Appendix A - Summary of Submissions

Appendix D - Updated Engineering Drawings

| Revisions | | | | Verified | Date | Microfiled | Associated Job Nos | Survey Data | | Scales | | SUNSHINE COAST REGIONAL COUNCIL LANDSBOROUGH TO NAMBOUR RAIL PROJECT | | NORTH COAST LINE: CABOOLTURE TO GYMPIE FOUR TRACK: WORKING PLAN AND SECTION 95 300 m - 96 060 m SHEET 19 OF 28 | | Queensland Government | | | | | | | | | |

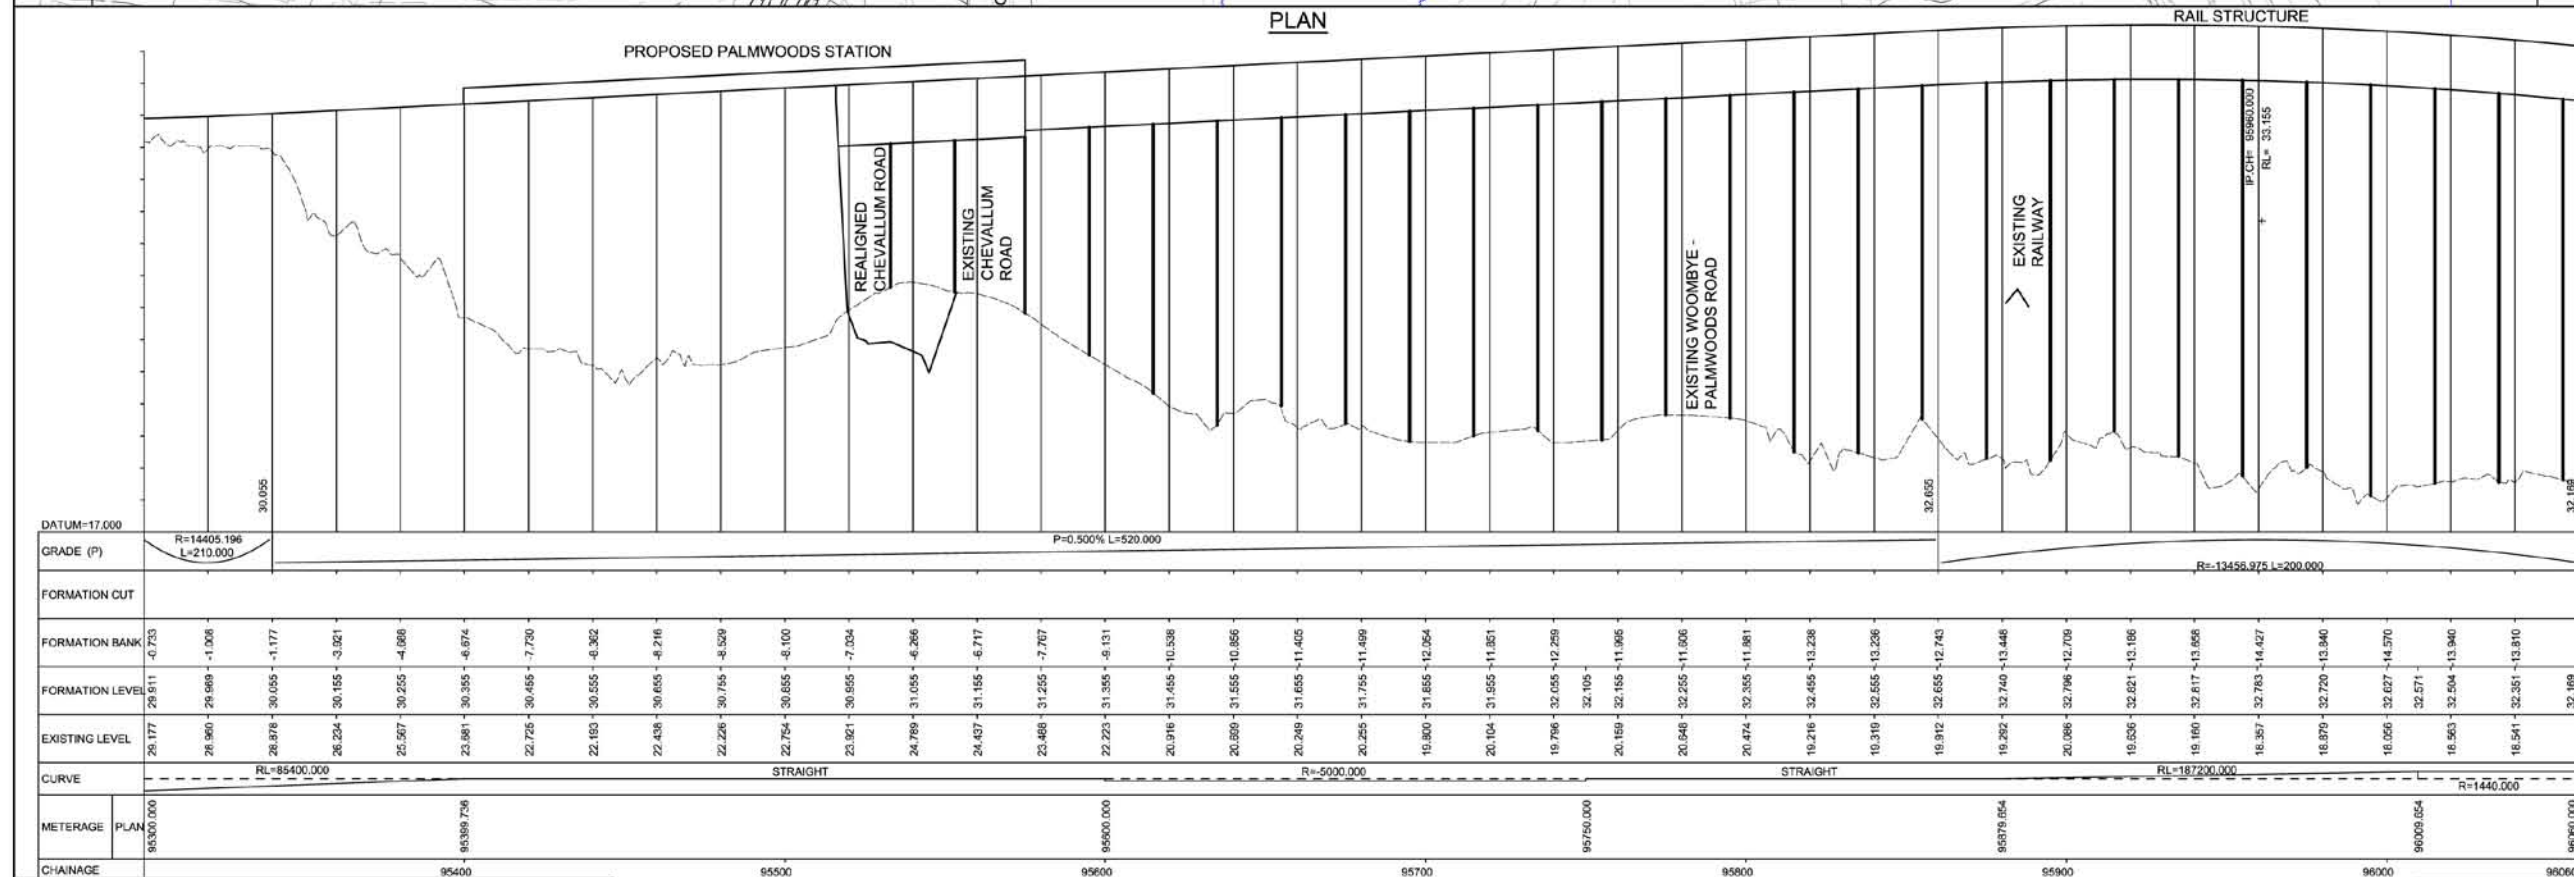
| Submitter | Sub Ref. | Comment Summary | Response Summary | Location in Supplementary EIS |
|-----------|----------|--|---|-------------------------------|
| | 53.163 | <p>See notes for Drawings C019 and C119 for comment.</p> <p>Concerns exist for visibility deficiencies to the right side from Nicklin Road onto Realigned Chevallum Road purely for distance but also due to bridge pier locations causing obstruction.</p> | <p>Noted on drawings, which will be incorporated into TMR project documentation so that they can be followed up during future stages of design.</p> | |
